## Technical change to HDC RockStar® ModuPlug MBUS 2

PCN-number:	PCN-PB72-20200131-00-A
Date of publishing:	2020, January 31
Duration of validity:	Until further notice
Revision number:	00-A

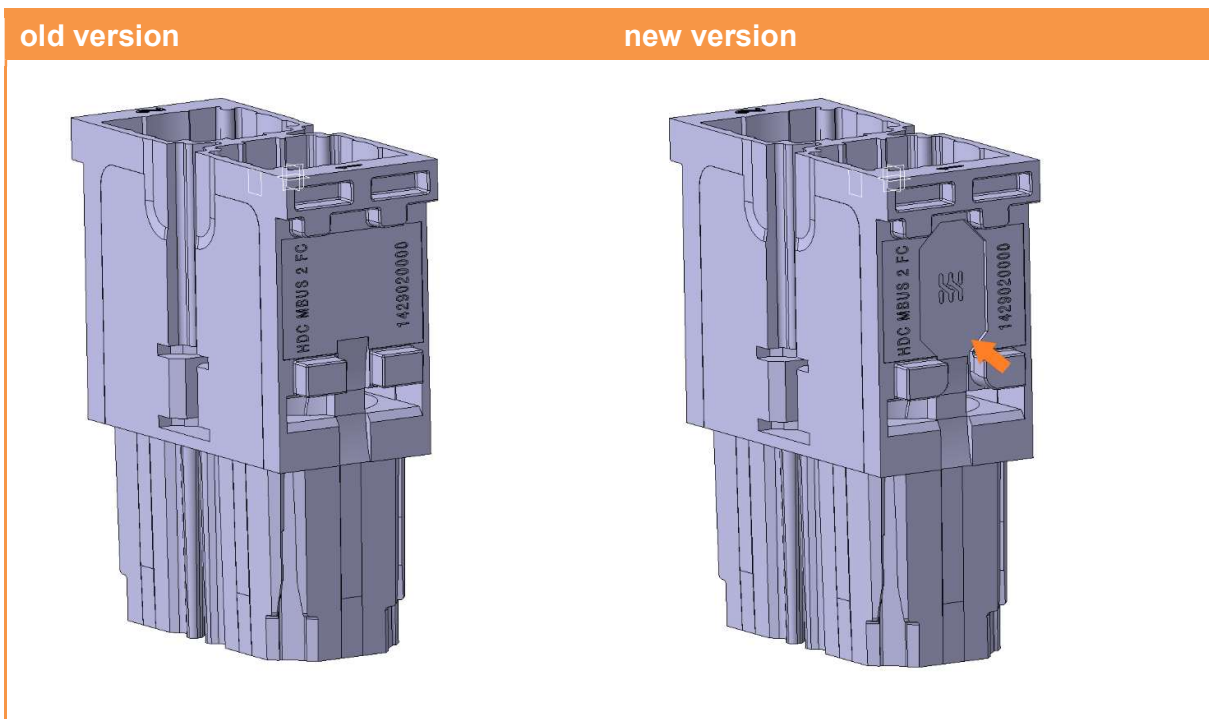
Possibility of a conductive connection between ModuPlug frame and shield contact.

- Geometrical optimization of the contact carrier to accommodate a metal clip.
- Printing optimized. Raised lettering replaced by laser printing.

- Product improvement
- Possibility to accommodate a metal clip
